TRAFFIC AND PEDESTRIAN STRATEGY

THE ESPLANADE AND BELL STREET TRAFFIC AND PEDESTRIAN STRATEGY
THE ESPLANADE AND BELL STREET, TORQUAY
22 JUNE 2017

CLIENT: Surf Coast Shire Council

Project title	The Esplanade (Zeally Bay Rd to Bell St) and Bell Street, Torquay	Review stage	Existing Conditions
Project manager	Aoife Corcoran	Designer	N/A
Road Safety Auditors	Jemima Macaulay, Associate, O'Brien Traffic Matt Harridge, Director, O'Brien Traffic

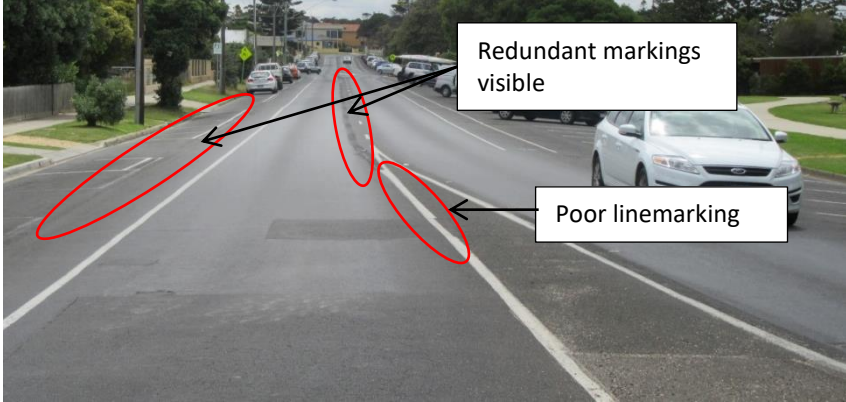
Issue No.	Review Findings & Recommendations	Risk	CLIENT RESPONSE	
			Accept: Yes / No	Reasons / Comments
1	<p>Poor provision for pedestrians crossing The Esplanade between Price Street and Gilbert Street</p> <p>The Esplanade has a wide carriageway (approximately 13-15m wide) which pedestrians must negotiate to cross the road. Refuge islands are provided at Price Street, Gilbert Street and Zeally Bay Road to assist pedestrians. However there are no crossing facilities between Price Street and Gilbert Street, a distance of over 400m. Given the high pedestrian demand (particularly in the summer months), an additional pedestrian crossing facility should be provided, desirably close to Anderson Street.</p> <p>Recommendation 1: Provide a pedestrian crossing facility on The Esplanade in the vicinity of Anderson Street.</p>	Medium		
2	<p>Line marking</p> <p>Line marking on sections of The Esplanade is faded and redundant markings are visible, including where lines have been blacked out (see Photos 1 and 2). This may be confusing for motorists, particularly in dark, wet conditions.</p>	Low
